| Subject: VARIOUS AUDIO SYSTEM CONCERNS WITH TUNER AND AMP UNIT (TAU) | Bulletin No: 09-038/13 |
| | Last Issued: 12/19/2013 |

2014 Mazda3 vehicles (with MAZDA CONNECT) with VINs lower than JM1BM*****109600 (produced before September 1, 2013)

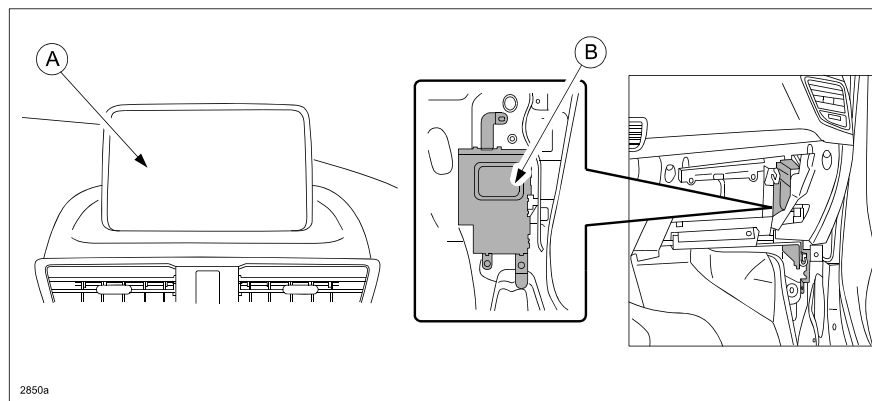
Some vehicle may experience any one of the symptoms below that can be resolved with a modified TAU.

- AM/FM/XM cannot be selected as they are grayed out
- Radio station returns to 87.9MHz on its own
- Audio sound setting resets on its own
- TAU version is displayed as “not available”

1. Verify customer concern.
2. On vehicle with a touchscreen (A), remove the TAU (B) and replace with a modified one. Refer to MS3 online instructions or Workshop manual (section 09-20 TUNER AND AMP UNIT (TAU) REMOVAL/INSTALLATION).
